## **Addendum Design and Access Statement:**

Revised Alterations and Extension: 58 Regent's Park Road, London NW1 7SX.

Document Ref: 139-D01-120709- Addendum Design and Access Statement (revised design)  
July 2012

Rear aerial view

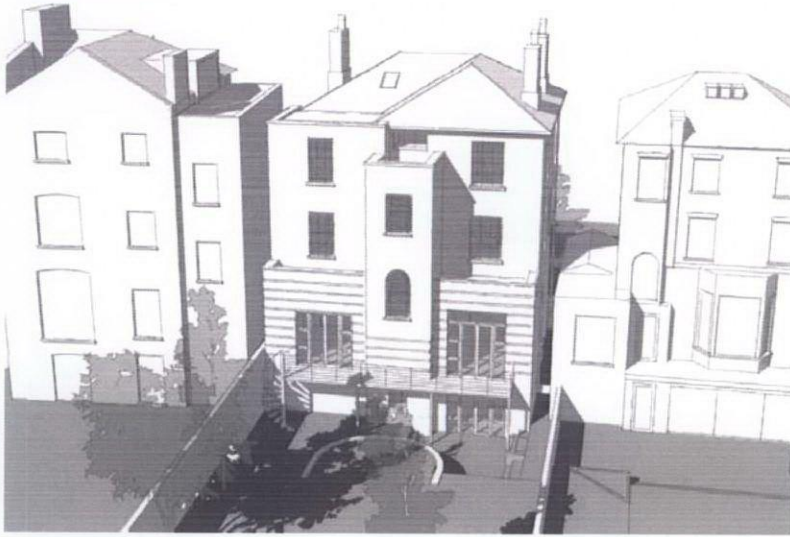
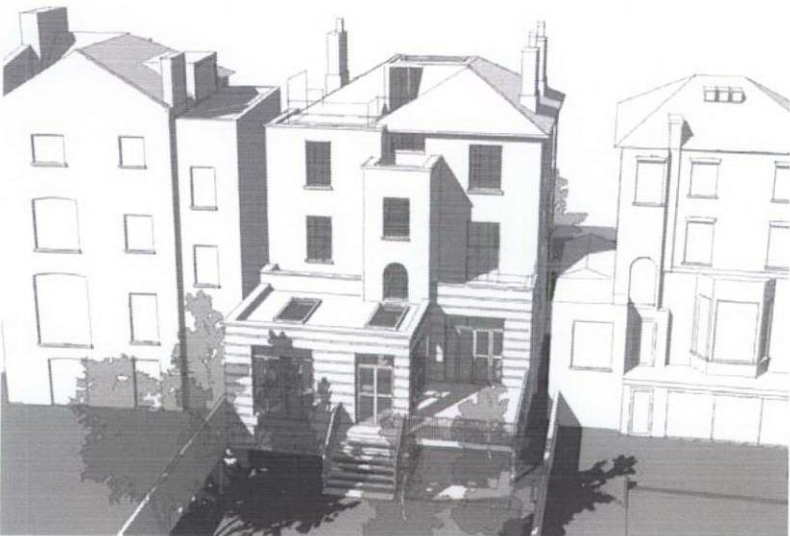
Further to the above information we have taken the opportunity to include updated sketches of 2 key views of the rear of the property. These are set out on the following 2 pages and show the existing context, the design as previously submitted and finally the revised proposal.

Fig 2. Sketch Render showing existing rear elevation- Existing condition.

Fig 3. Sketch Render showing previous proposed rear configuration – Withdrawn application Ref: 2012/2424/P

Fig 4. Sketch drawing showing proposed revised rear configuration.
